Subject: Oyster Creek Nuclear Generating Station  
Operating License No. DPR-16  
Docket No. 50-219

Technical Specification Change Request No. 203  
Tech. Spec. 24-Month Surveillance Extensions  
Supplemental Information Requested by NRC (TAC No. M96906)

**Technical Specification Change Request No. 203**

## **SUPPLEMENTAL INFORMATION**

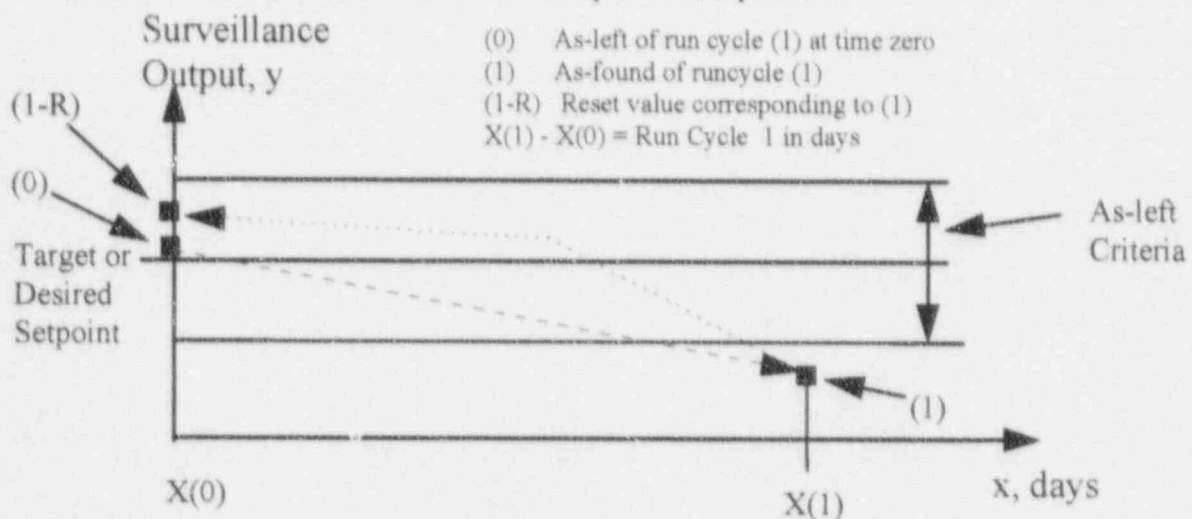
Every time a switch is adjusted with respect to a bellows, the run time for that switch-bellows combination is set to zero (0). If a switch was adjusted at the previous surveillance its run cycle was set to zero then and at the next surveillance it was again adjusted, in such case there will be two sample or data points.

Process Run Cycle No. 1, Days  
 # of data points = 2, i.e., (0) & (1)

Figure 1 is a graph showing Surveillance Output,  $y$ , versus  $x$ , days. The graph illustrates the effect of a reset on the output of a surveillance system. The y-axis is labeled "Surveillance Output,  $y$ " and the x-axis is labeled " $x$ , days". A horizontal line represents the "Target or Desired Setpoint". The output starts at  $(X_0)$  and follows a dashed line  $(S_1)$  to the first surveillance point. At the first surveillance point, the output is  $(1-R)$ , which is above the target. At the second surveillance point, the output is  $(2-R)$ , which is below the target. At the third surveillance point, the output is  $(2)$ , which is above the target. The output then follows a dotted line  $(S_2)$  to the next surveillance point. The output is then reset to  $(2-R)$  at the third surveillance point. The graph shows that the output is above the target for the first two surveillance points and below the target for the third surveillance point. The output is then reset to  $(2-R)$  at the third surveillance point. The graph shows that the output is above the target for the first two surveillance points and below the target for the third surveillance point. The output is then reset to  $(2-R)$  at the third surveillance point.

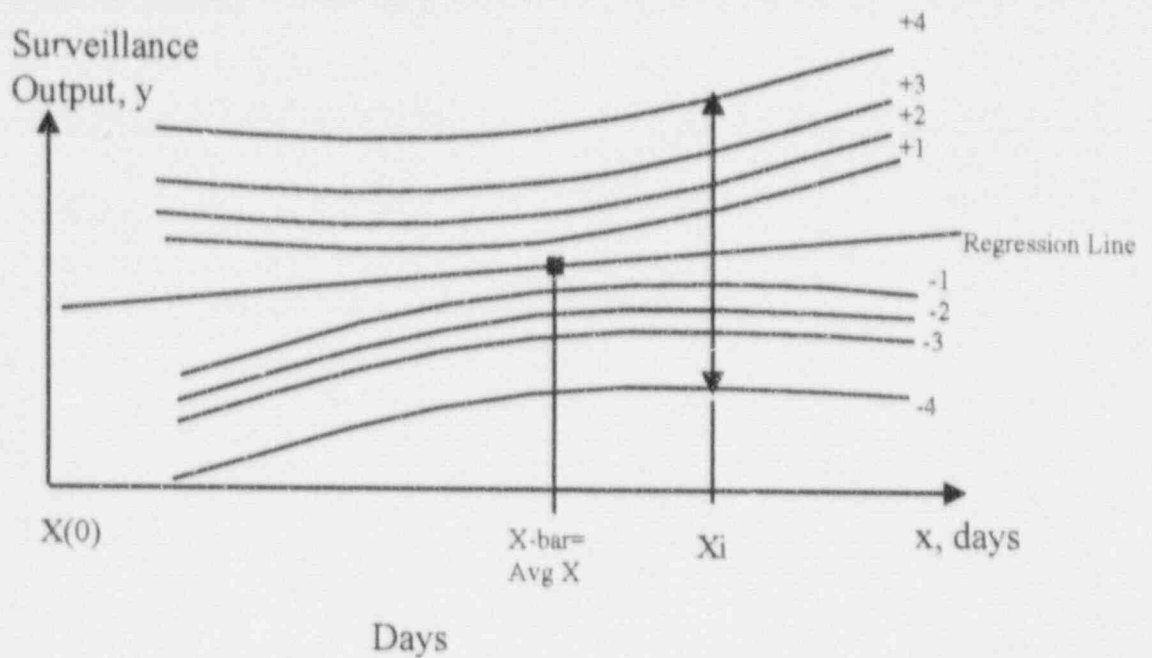
Thus the variance of the predicted value is enlarged by the sum of: Variance of the estimate, Variance of  $\bar{y}$  and Variance of the slope multiplied by the square of the deviation of the predicted time from the average value of  $X$ .

In the figure above,

$\pm 1$  = Variability around regression line due to standard deviation of the estimate

$\pm 2$  = Variability around regression line due to square root of {variance of the estimate + variance of  $\bar{y}$ }

$\pm 3$  = Variability around regression line due to square root of {variance of the estimate + variance of  $\bar{y}$  + (variance of slope)  $\times$  (square of the deviation from the  $\bar{X}$  of time for which the prediction is made)}

$\pm 4$  = 95% Confidence Interval around regression line  
 $= t_{(95, DF)} \times \{\pm 3 \text{ from directly above}\}$
